LOW VOLTAGE CIRCUIT BREAKER SALES & SERVICES

NO. YAMA389

Specification change of front bar for 400A frame MCCBs and ELCBs

1. Types

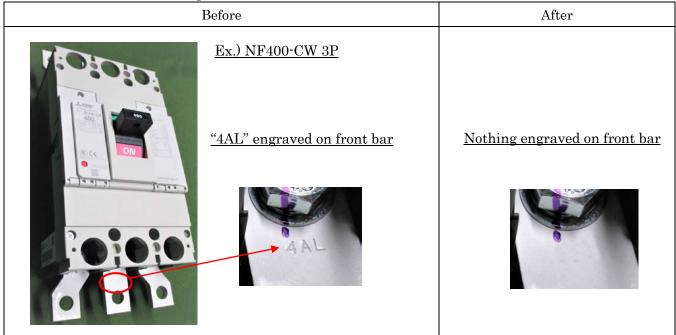
To delete the "4AL" mark engraved on the front bar.

In accordance with the change in IEC6047-2 Ed4.2 to Ed.5.1, the "Al" mark has been added to the aluminum conductors. Therefore the "4AL" mark will be deleted for avoiding the confusion.
